265 Russett Road Chestnut Hill MA 02467

Mr. Jesse Geller, Chairman

Brookline Zoning Board of Appeals

Dec 17, 2014

Attachment 3 : Final waiver list

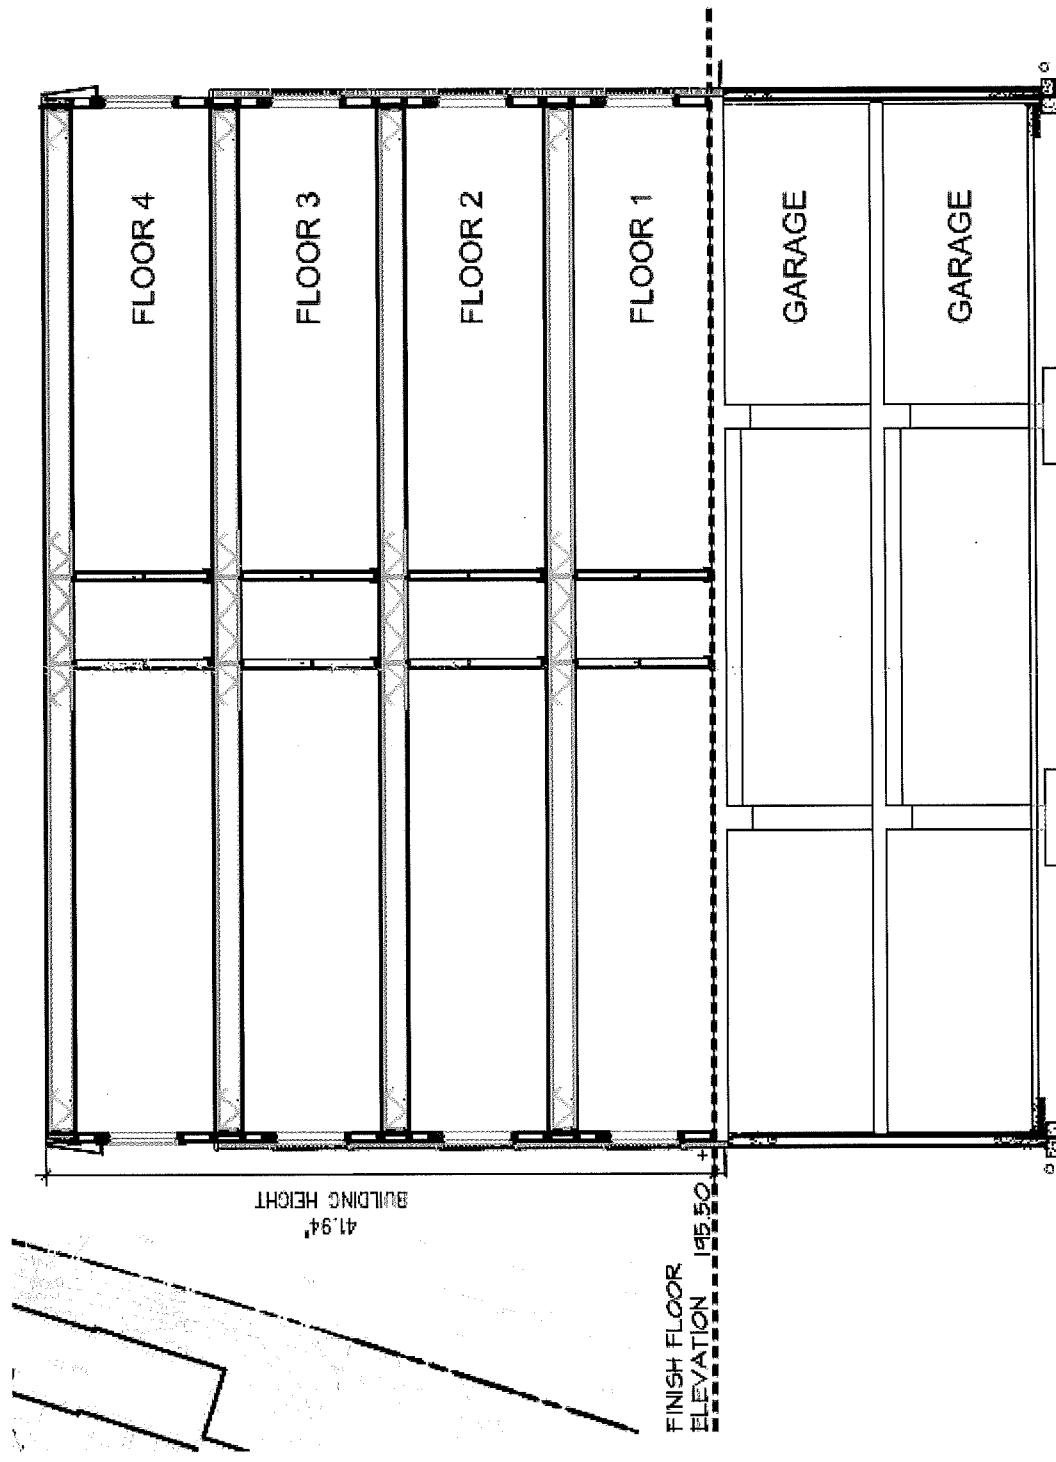
2. The waiver list states that the allowed height is 216.3 feet. The calculation box (using the formula stated as "Method C") lists either 215.78 or 256.34 (attachment 6). I do not see any explanation of the 216.3 feet.

3. The actual height allowed by Brookline Bylaws is 35 feet over the record grade at the midpoint of the lot which would be 211.8 by their calculations. Any attempt to use Section 5.30 would result in a *lower* allowed height.

Figure 5.05 - Measurement of Building Height When the Rear Abutting Lot is Subject to Same or Less Restrictive Height Limitation

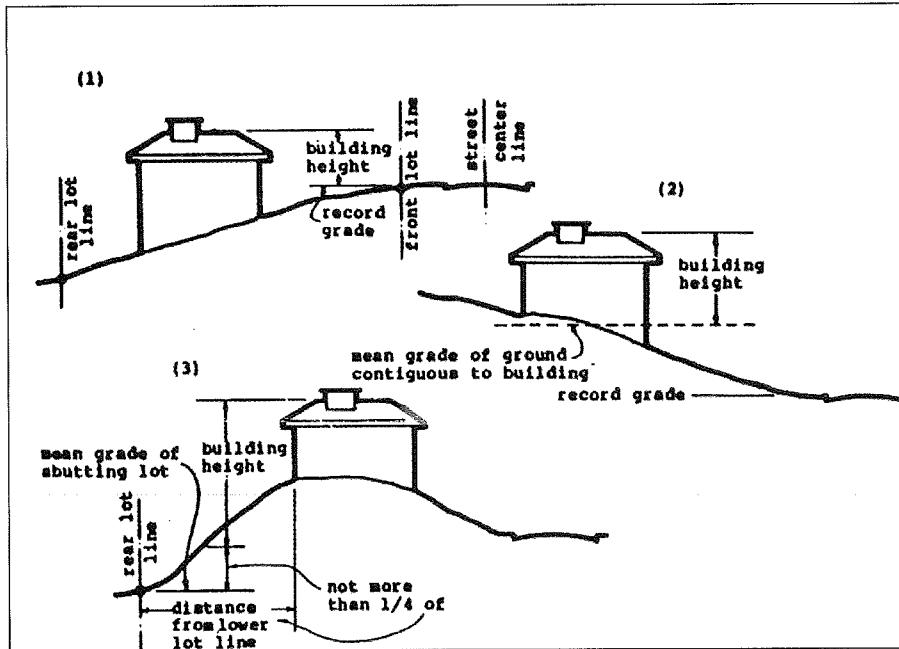
I have previously stated that the CHR interpretation of the Zoning Bylaws is erroneous and is clearly at odds with the diagram that accompanies the written description. The diagram in Section 5.30 (attachment 7) explicitly shows that the height of a building on a hill must be *less* than the Bylaws otherwise allow. By the CHR interpretation, there is essentially unlimited building height, and as shown in Attachment 8, a one foot slope would allow a building of over 600 feet tall if a plot of land $\frac{1}{2}$ mile long with a slope of 1 foot is available (attachment 8).
